**Technical Service Bulletin (TSB)**  
**Second Row Middle Seat Belt Does Not Retract**

<b>REFERENCE:</b>	<b>TSB:</b> 23-018-23 <b>GROUP</b> 23 - Body	<b>Date:</b>	February 1, 2023	<b>REVISION:</b>	-
<b>VEHICLES AFFECTED:</b>	2022 (WS) Grand Wagoneer/Wagoneer Built on or after January 1, 2022 (MDH0101XX) and on and before July 22, 2022 (MDH0722XX) equipped with the Eight Passenger Seating (Sales Code CYF).			<b>MARKET APPLICABILITY:</b>	
				<input checked="" type="checkbox"/> NA	<input type="checkbox"/> MEA
				<input type="checkbox"/> SA	<input type="checkbox"/> IAP
				<input type="checkbox"/> EE	<input type="checkbox"/> CH
<b>CUSTOMER SYMPTOM:</b>	Second row middle seat belt does not retract.				
<b>CAUSE:</b>	<b>Either the:</b> <ul style="list-style-type: none"> <li>• The plastic bezel was misaligned at assembling station.</li> <li>• The guide holes do not align.</li> <li>• Holes on the frame are out of position 3 mm (tol ±0.5 mm).</li> </ul>

**Fig. 1**  
**Torx Screws**

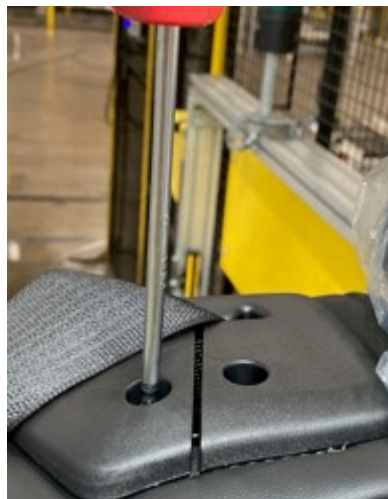
1. Remove the two T-30 Torx screws. ([Fig. 1](#)) .

**Fig. 2**  
**Seat Belt Guide Plate**

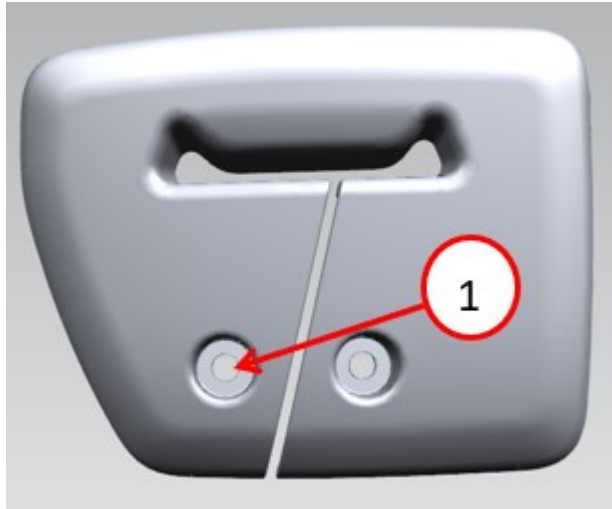
2. Remove seat belt guide plate and increase this hole diameter to 8mm (5/16") ( Fig. 2) .

1 - Hole to Modify

3. Reinstall plate and ensure belt retraction operation.
4. Verify any other customer seat concerns with the latest available bulletins. Refer to all applicable published service bulletins for detailed repair procedures and labor times regarding updating the seat concerns.
